Comments in magenta red provided by
Slantern@auroragov.org (Drainage)

Preliminary Drainage Report For Foundry Filing No. 1

Aurora Water Drainage

HEC-RAS Plan: 2-year-shear River: Foxtail Run Reach: 1 Profile: 2-YR

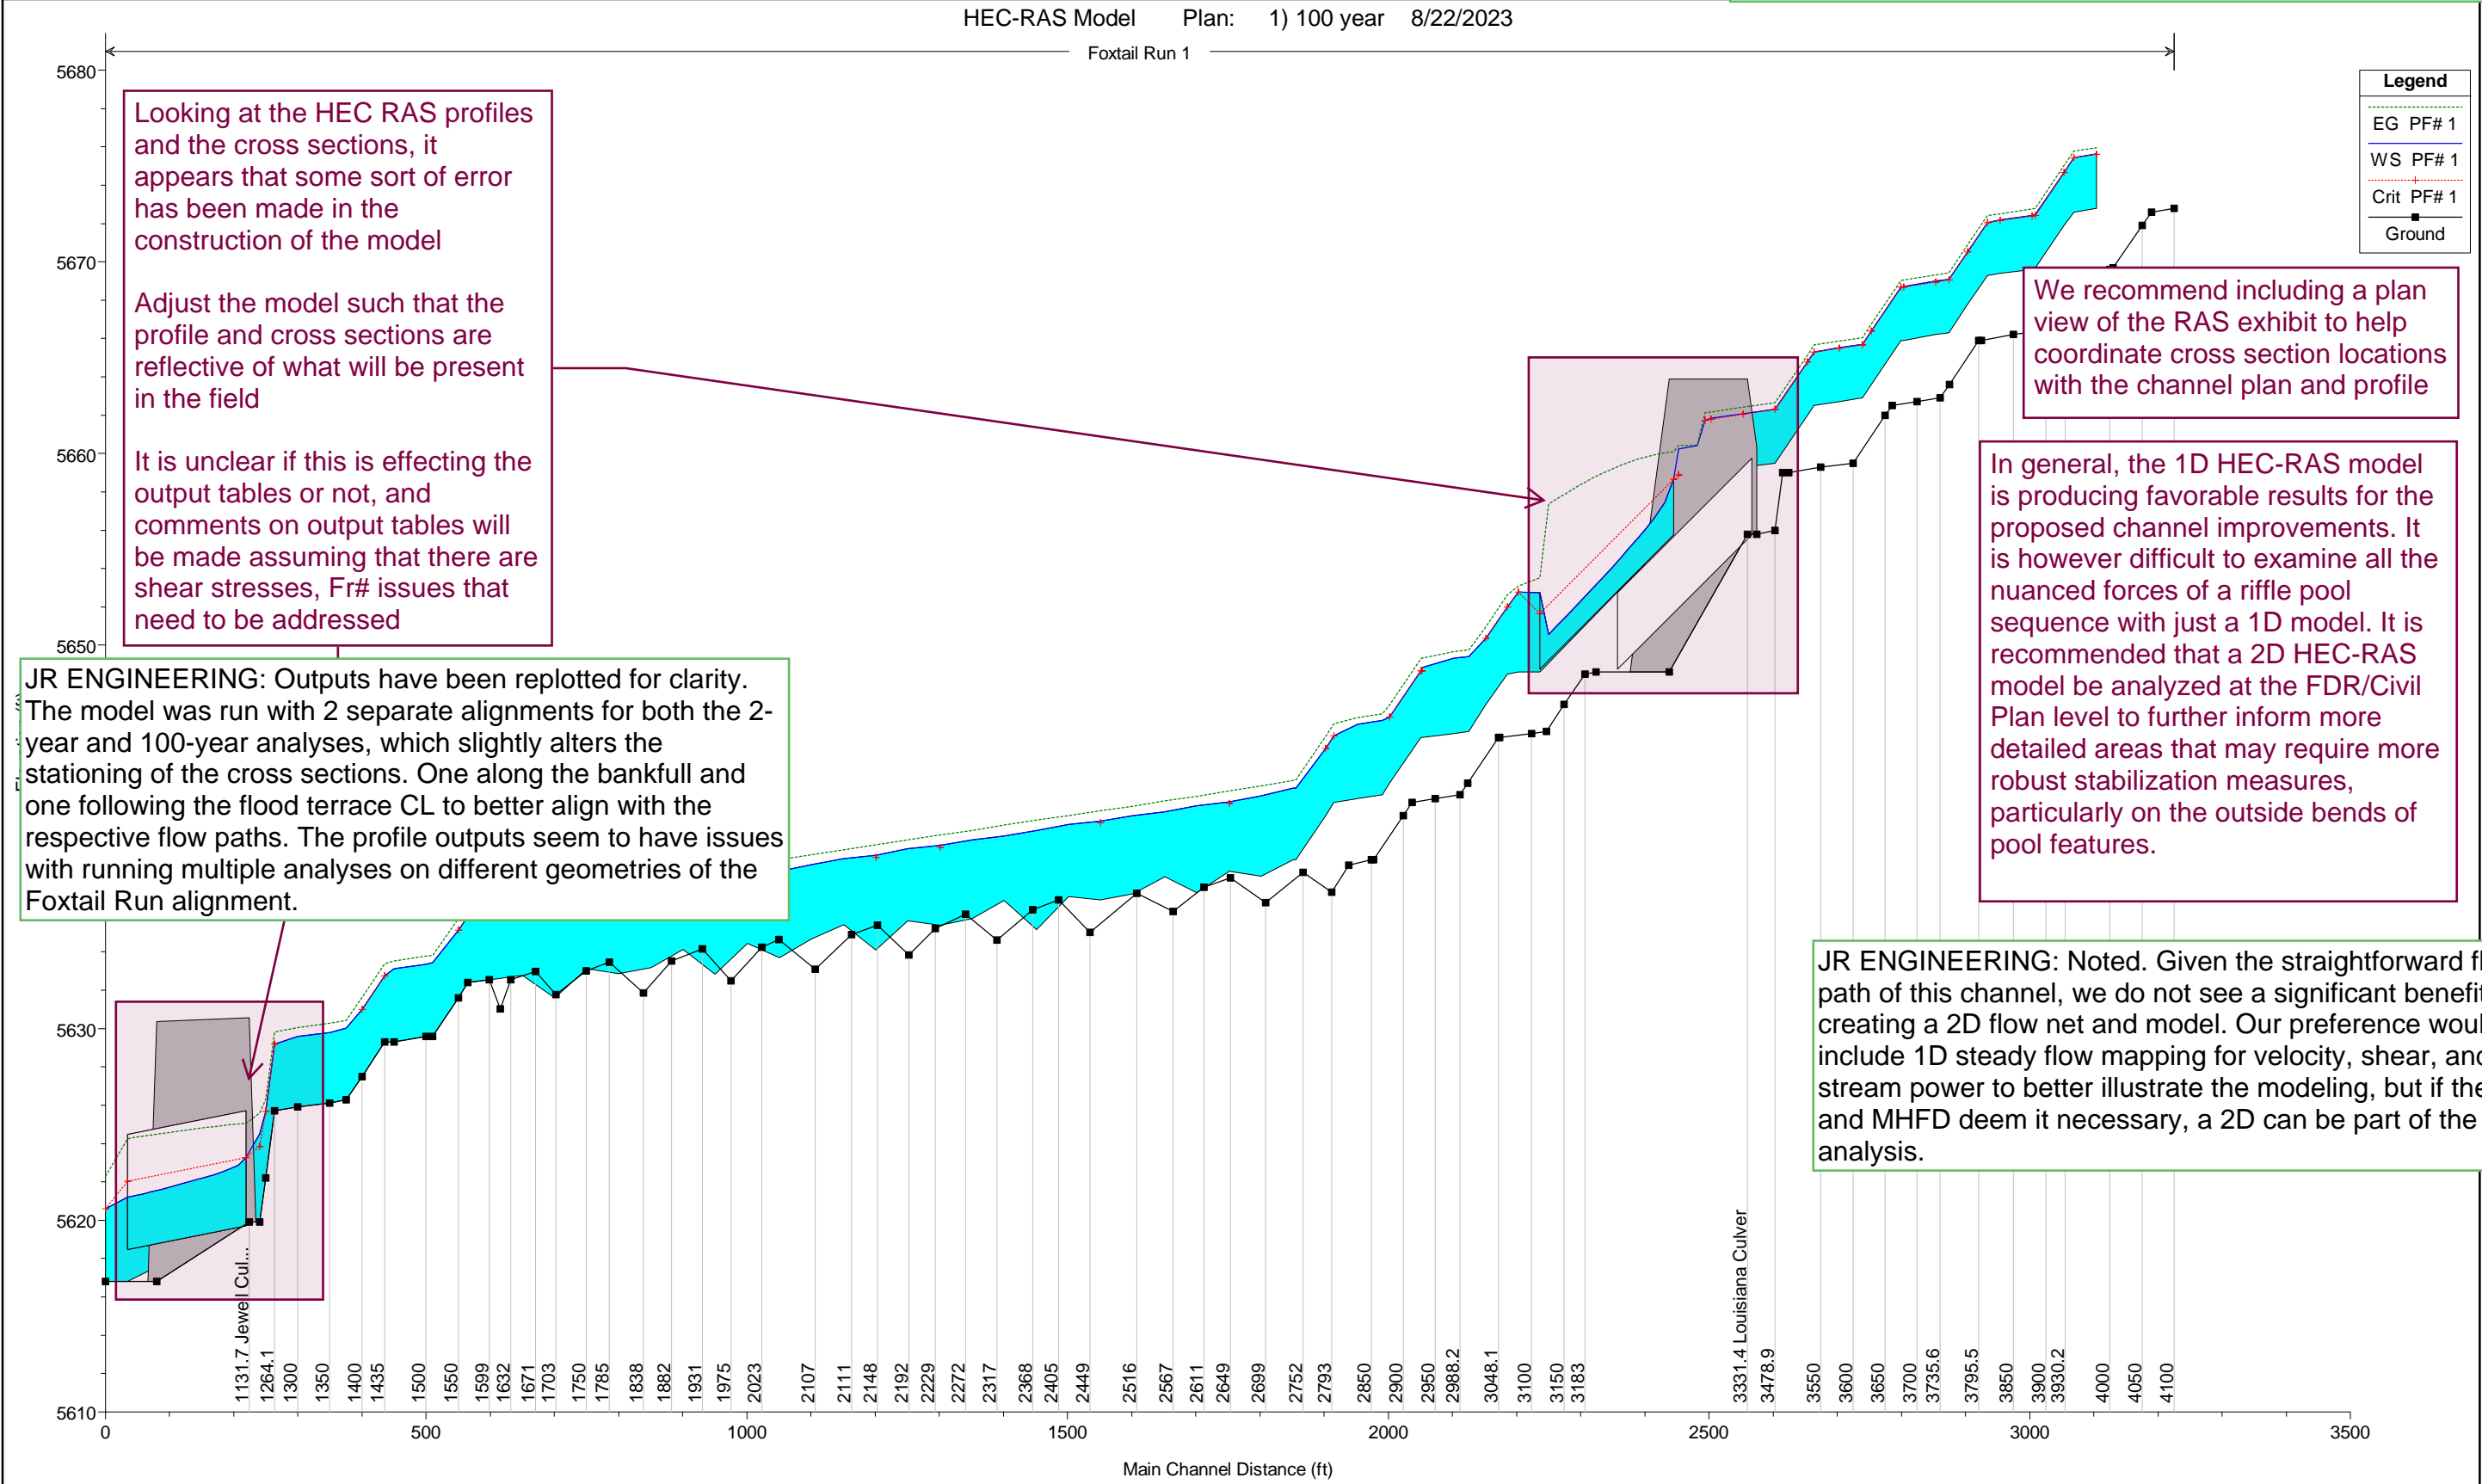
Adjust the model such that the profile and cross sections are reflective of what will be present in the field

It is unclear if this is effecting the output tables or not, and comments on output tables will be made assuming that there are shear stresses, Fr# issues that need to be addressed

JR ENGINEERING: Plan View for the HEC-RAS model has been added to the appendix

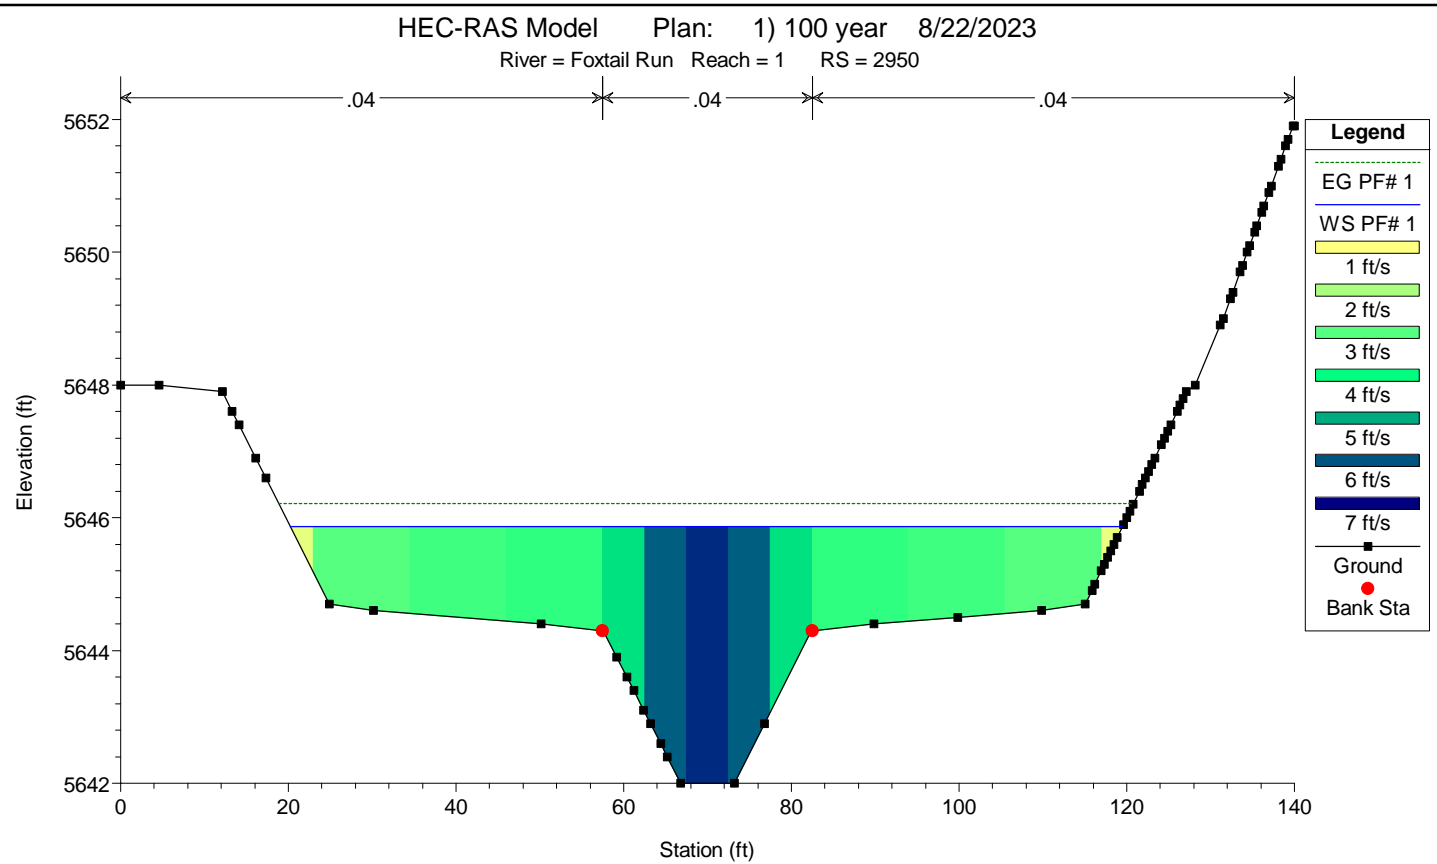
As commented on previously,
please adjust the ineffective flow
areas (IEFA) on cross sections
near culvert crossings. The
upstream culvert IEFA is currently
set to the soffit of the culvert pipe,
but it should be set to the
overtopping elevation of the road.
The IEFA is currently being
negated in the 100-year model in
this area.

JR ENGINEERING:
IEFA elevation has
been update to the
overtopping
elevation.

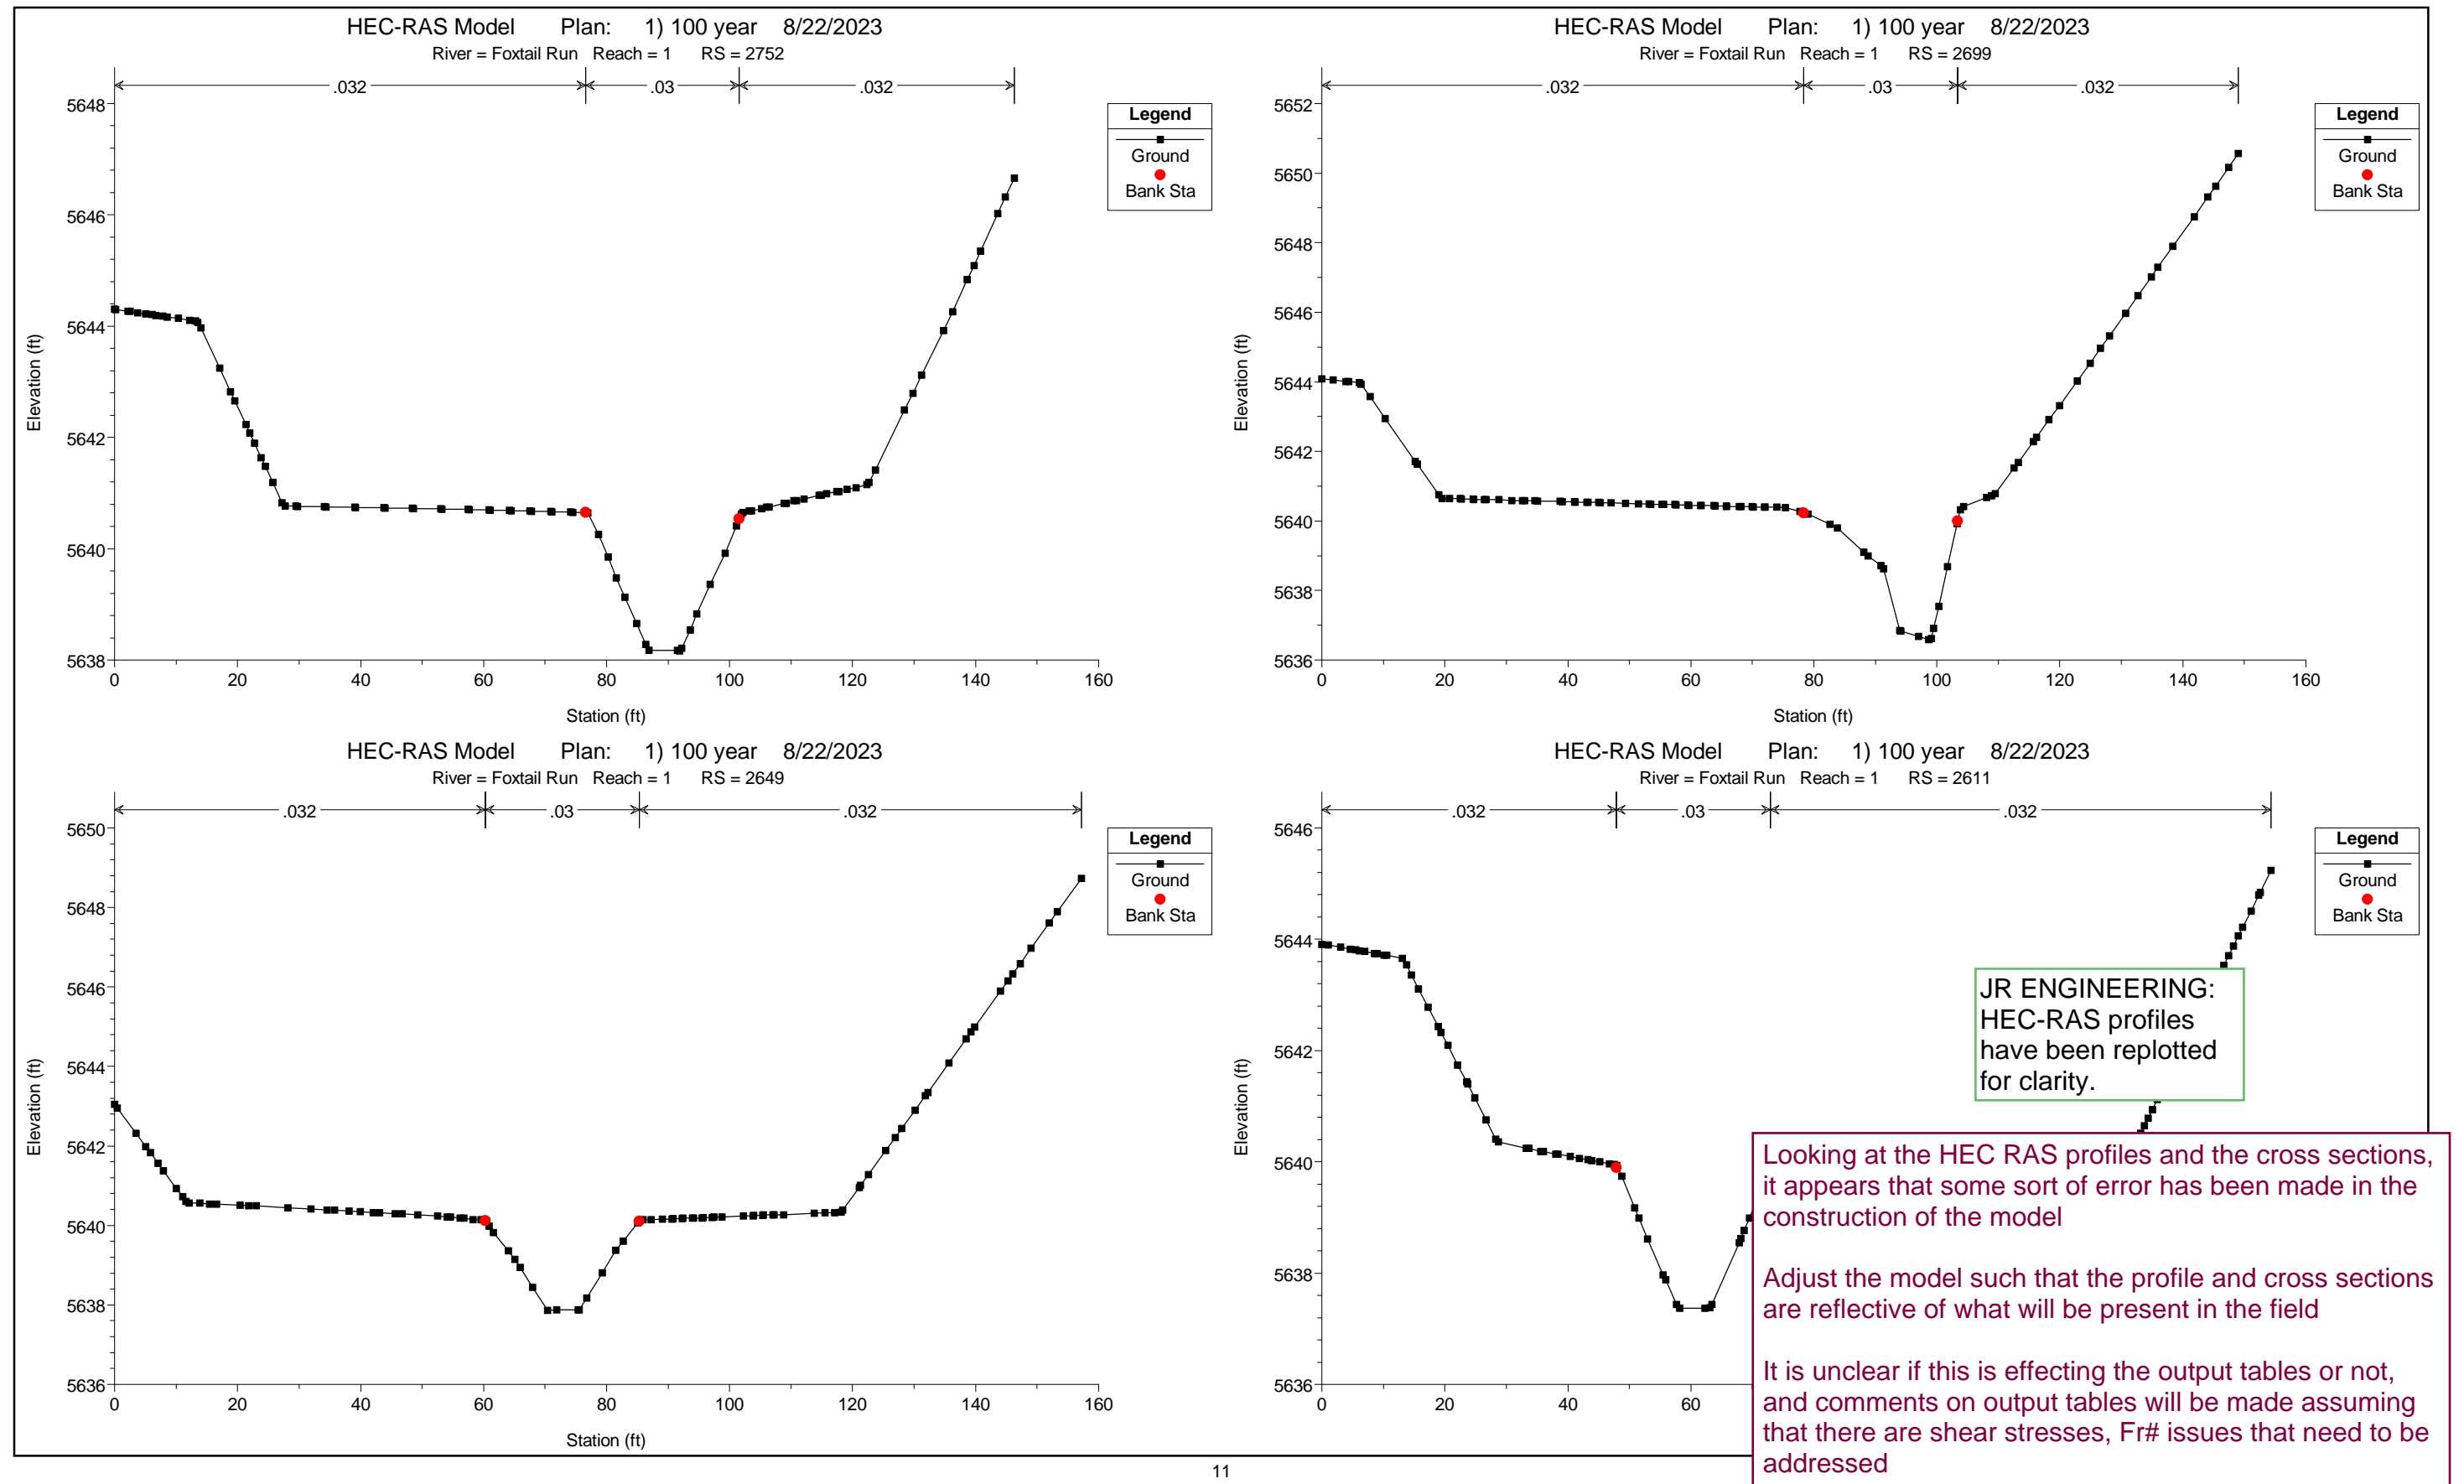
Adjust the model such that the profile and cross sections
are reflective of what will be present in the field

It is unclear if this is effecting the output tables or not,
and comments on output tables will be made assuming
that there are shear stresses, Fr# issues that need to be
addressed

JR ENGINEERING:
HEC-RAS profiles
have been replotted
for clarity.
